Independent Review of Funding Request for Western HVDC Link

STAGE 1: NEED CASE

- Final - Public version
- 1 August 2011

■ **Figure 4 Scottish Renewables. Updated generation scenarios**

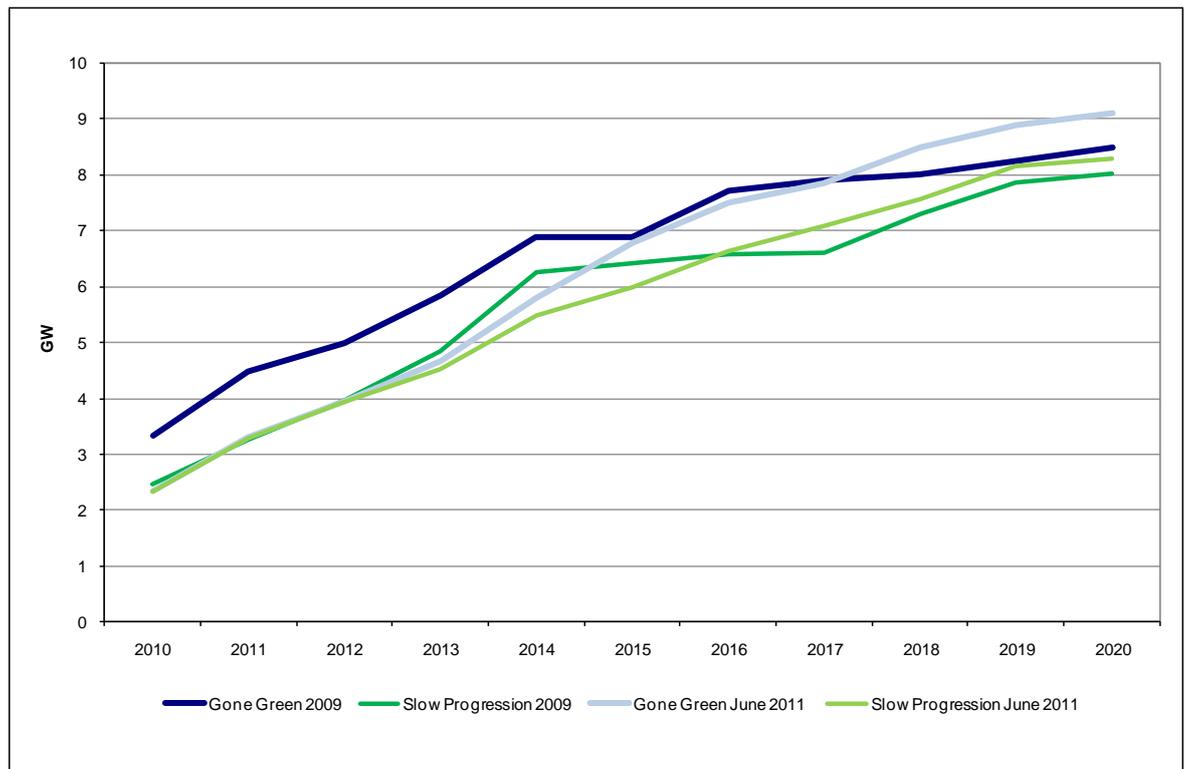
The chart highlights a number of points:

- SP has been more representative of actual renewable growth since 2008/9 than GG, emphasising the underlying optimism that characterises GG.
- The revised June 2011 GG and June 2011 SP scenarios are almost identical to 2013/14. SKM considers the similarity between the two updated scenarios inevitable in the short term given the timing of plant construction.

■ **Figure 5 Estimate of boundary capability with Eastern HVDC link and Penwortham-Kirkby upgrade**

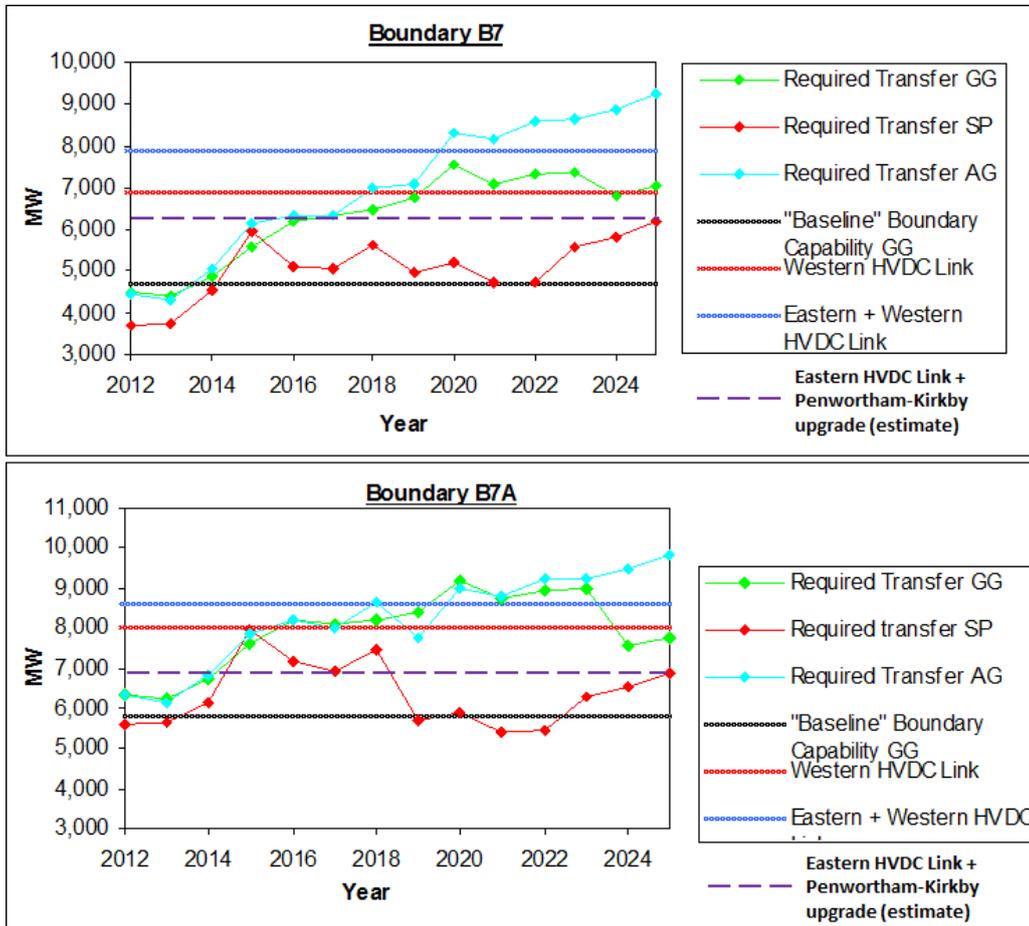
Figure 5 shows an estimate of the boundary capability across B7 and B7a with the Eastern HVDC link and Penwortham-Kirkby upgrade using the charts in Table 2. The capability has been estimated from the difference between the Eastern and Western HVDC lines in the charts in Table 2 added to the baseline capability and also adding 600 MW for the link. The results (shown in a dashed line) indicate that in the case of B7, the boundary remains compliant until 2018 under all scenarios, and compliant all over the period to 2025 under SP only. However in the case of B7a and over the period to 2018 the reinforcement does not seem to provide sufficient capacity for any scenario noting that under SP some years the violations seem small. The boundary is non-SQSS compliant over the period for GG and AG.

■ **Figure 6 B7a seasonal boundary capacity with alternative reinforcements**

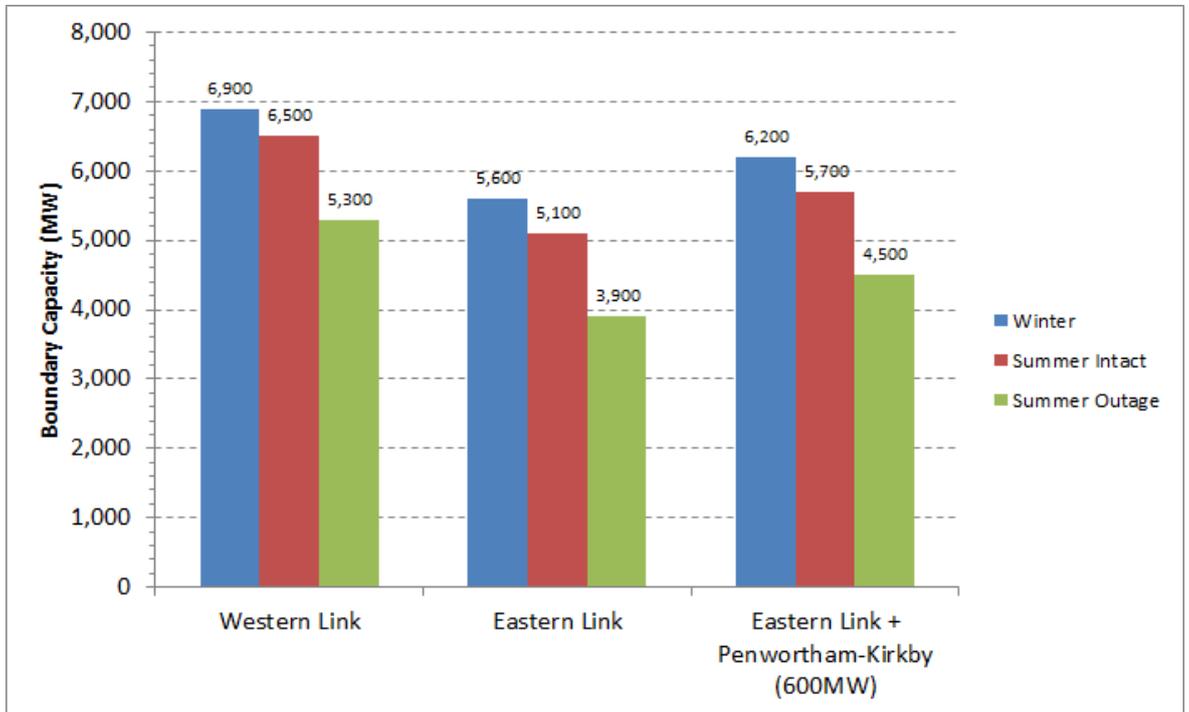
Similar but more precise results can be drawn from examination of the seasonal boundary capacities indicated in the CBA report for B7a and presented in Figure 6 below. We have also estimated the effect of adding the Penworthan to Kirkby reinforcement as a 600MW increase of capacity (not seasonally adjusted due to lack of further information). The charts show that the Western Link is superior to the alternative Eastern Link + B7a reinforcement by about 700 MW-800 MW.

We conclude therefore that the reinforcement raised by KEMA is not really an alternative to the Western HVDC Link as, even if coupled with the Eastern HVDC Link, it would not resolve the SQSS compliance issues of the B7a boundary to 2019 as it provides about 700 MW less boundary capacity compared to the Western HVDC Link.

It should be noted however that the boundary capacities for 2020 presented in Figure 6 for the Western HVDC Link are significantly below the boundary capacity for B7a in the boundary capability charts in of NGET/SPTL June 2011 submission (based on the ODIS 2011 submission) by about 1000MW. The June2011 CBA submission justifies this reduction as the effect of closing Teesside Power closed in all scenarios that, according to NGET, "...affects the load-sharing across the western and eastern circuits comprising B7a profoundly". This also indicates that the capability requirements indicated in the boundary capability charts B7a included in NGET/SPTL June 2011

■ **Figure 8 Changes in NGET losses modelling**

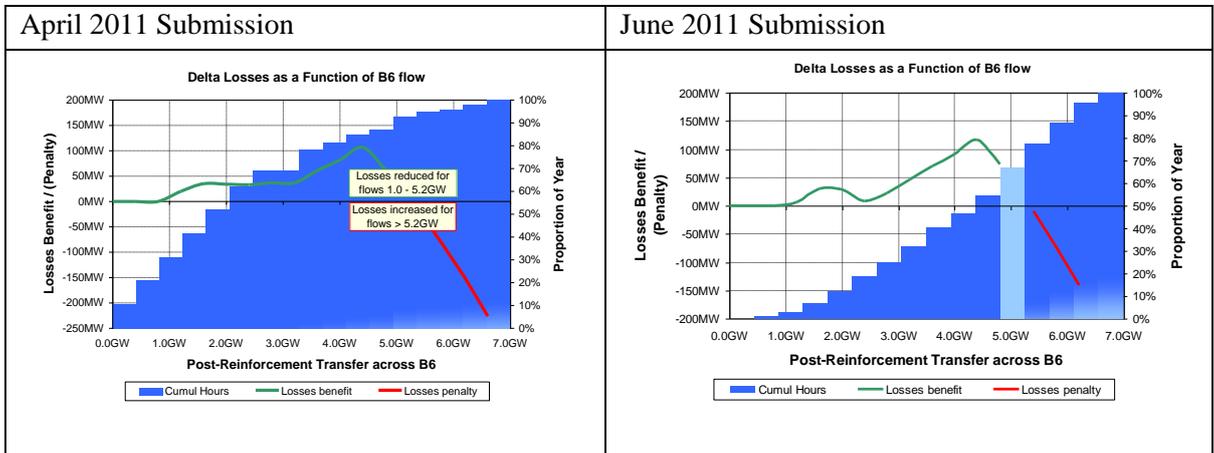
Figure 8 below show the difference in NGET/SPTL's assessment of losses. NGET/SPTL was asked to explain the differences in its assessment of losses, and has not formally done so. However, it has been suggested that the losses benefit differs between the two charts as each represents a different analysis of flows undertaken to minimise losses. In short the actions taken to minimise losses in modelling underpinning the April 2011 chart is different to the action taken in June 2011. NGET/SPTL were unable to explain the reasons for the change in 'shape' of the cumulative hours between the charts other than due to model improvements, but noted that different results will be provided by different scenarios and generation backgrounds. Also it is likely that the duration curve will change over time and with increased renewable generation in Scotland. It is unclear how this is captured in NGET analysis.

NGET/SPTL’s analysis suggests that a positive loss benefit will result from the Western HVDC link for flows up to 5.2 GW across the B6 boundary. At higher transfers, greater system losses will result than without the Western HVDC link – shown in charts where the green line becomes red. However NGET/SPTL conclude that the cost of additional losses will be offset by the reduced constraint costs incurred.

SKM notes the limited explanation and inconsistent results underpinning NGET/SPTL’s assessment of losses. SKM concurs that the proposed Western HVDC link will remain a lower loss route to transmit power than the AC system up to 5.2 GW across the B6 boundary. At higher transfer levels the losses benefit becomes negative – representing a cost. SKM concurs that it is likely that reduced constraint costs will be greater than the increase in the cost of losses and hence it represents a second order benefit. However we consider that this issue should be investigated further and the analysis improved in Stage 2.

■ Figure 10 Optimum start date under SP,GG and AG

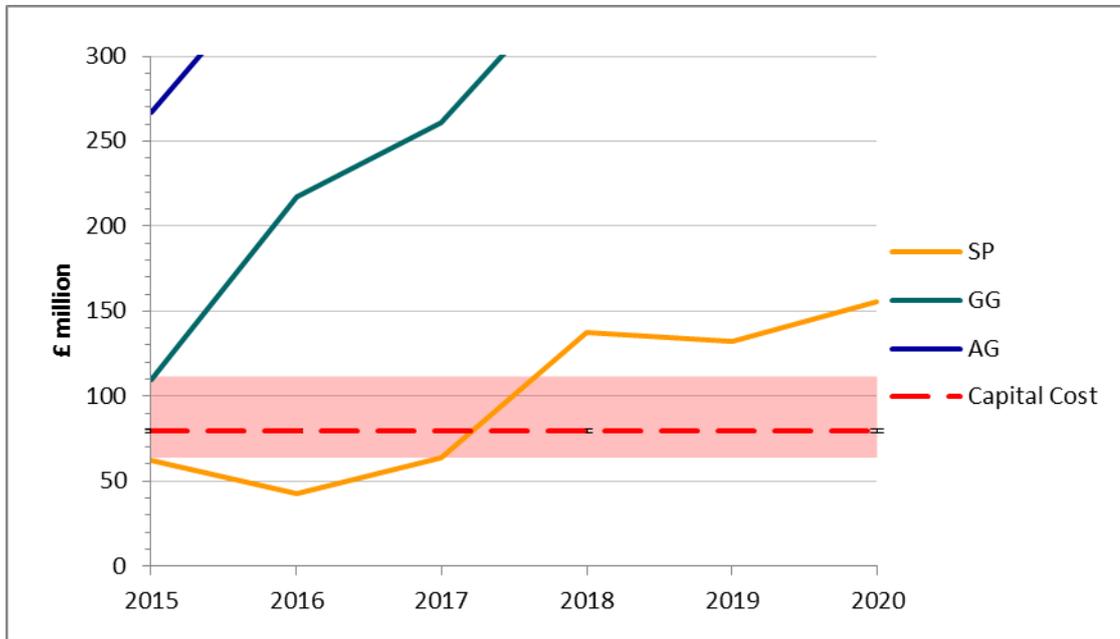
Figure 10 shows the annualised costs and benefits of the project. The results indicate that the annualised benefit of the project remains consistently above the annualised costs under GG and AG. However, under SP the annualised costs are higher than the annualised benefits until 2019 – based on NGET’s initial submission. Taking into account the benefit of losses of around £15m in SP would result in a required start date for the project of 2017/18.

As a result SKM considers that, under the SP scenario, the Western HVDC link does not seem to be justified until 2017/18 but under the GG and AG scenarios the earliest possible commissioning date of Dec 2015 seems justified.

■ **Figure 13 Summary of key sensitivity studies. SP**

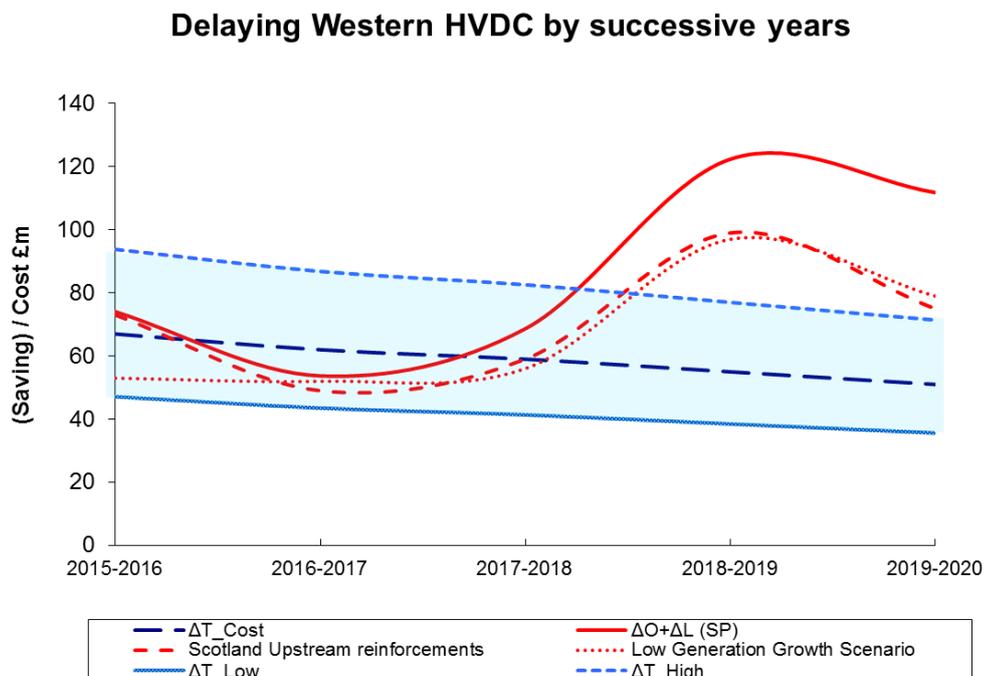
Figure 13 summarises the CBA results obtained for the SP scenario, which is the critical one when it comes to timing of the reinforcement. The red line is that used by NGET in their submission for SP (Figure 11).

Results do not change significantly as the majority of the constraints removed by the Western HVDC are across B6 and B7a and hence the results seem relatively insensitive to an increase in constraints in Scotland. In the case of the scenario with reduced renewable growth in Scotland a similar result is obtained. In this case however the inclusion of an extension to Hunterston limits the benefit of the reduction in renewable growth in terms of constraints.

In both cases the results hardly change and indicate an optimum delivery date of 2017/18 under the SP scenario. The constrain costs (red lines) are above the capital savings achieved from the delay from 2017 to 2018 (although within the high tolerance) and well above thereafter.

■ **Figure 14 Cost of getting the timing wrong, Red: Late – Green:Early (2 years)**

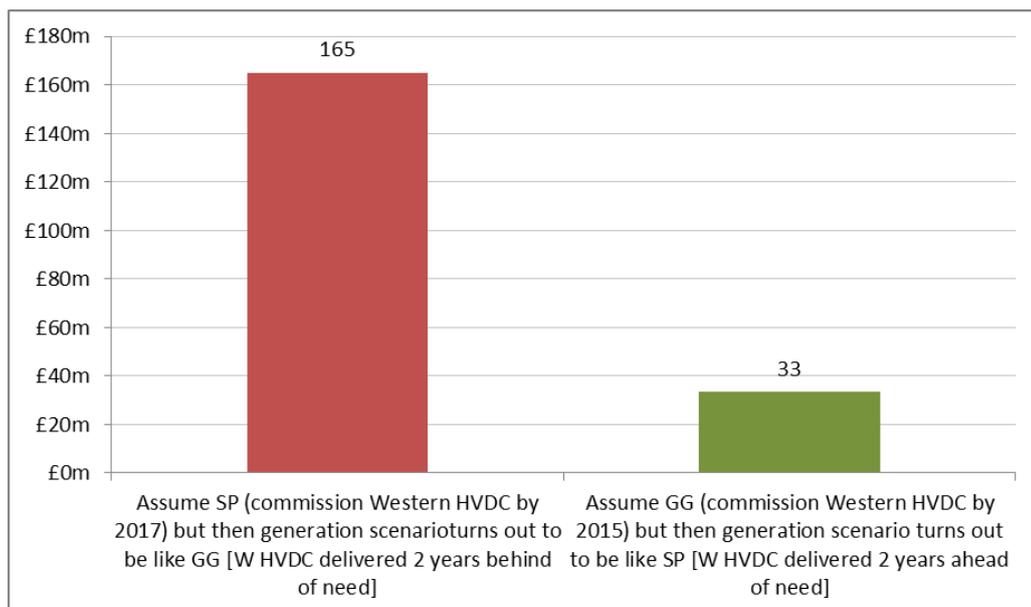
The analysis indicates (Figure 14) that if the Western link is commissioned in Dec 2015 and the renewable growth scenario turns out to be like SP the additional costs (via forwarding of capital cost) would amount to circa £33 million. If however the link is commissioned in 2017/18 (SP) and then the growth path looks like GG then the additional cost (via increased constraint costs) would amount to circa £165 million (i.e. about 5 times higher).

- **Figure 15 Cost of getting the timing wrong, Red: Late – Green:Early (2 years) including effect of electrical losses.**

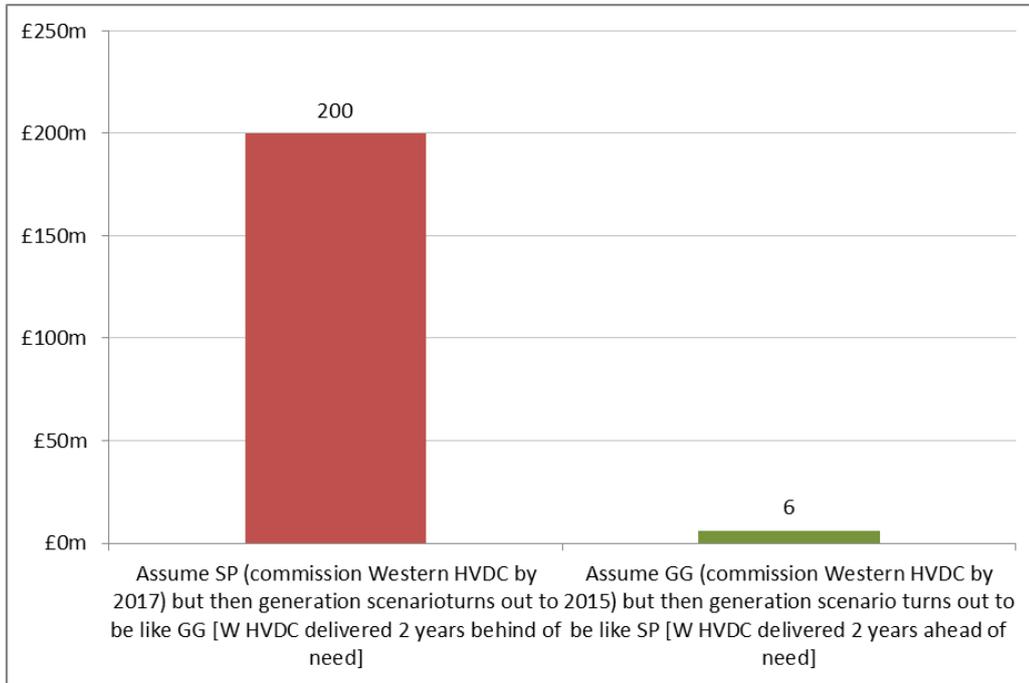
If losses are considered, as calculated by NGET/SPTL, then the spread in the costs increases to £6 million and £200 million respectively (Figure 15). It can be concluded that the potential cost of being wrong by delivering the project early could be very small whereas the cost delivering the project late could be very high.
